SUNNICA ENERGY FARM - RESPONSE TO STATUTORY CONSULTATION

December 2020

This document is the joint response of West Suffolk Council, Suffolk County Council, East Cambridgeshire District Council and Cambridgeshire County Council (referred to as “the Councils” in this response) to Sunnica’s Section 42 consultation. Unless it is identified otherwise in specific sections, the Councils share their views on matters within this response. Any views expressed in regards to East Cambridgeshire District Council are at an informal professional officer view only.

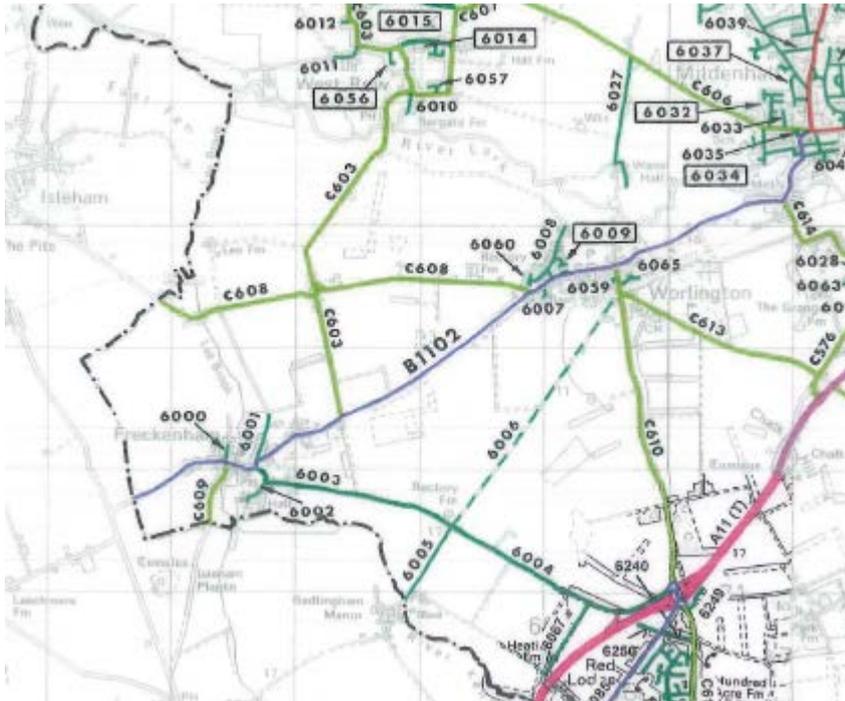
Figure 3 does not clearly show how HGV traffic from the A14 East accesses Sunnica West accesses A, C, D and E, but it is clear that many HGV routes use the A14 / A142 junction 37 at Newmarket. Understanding traffic movements at this junction are important not just in capacity terms, but also the impacts on road safety as there have been a number of accidents recorded at this location.
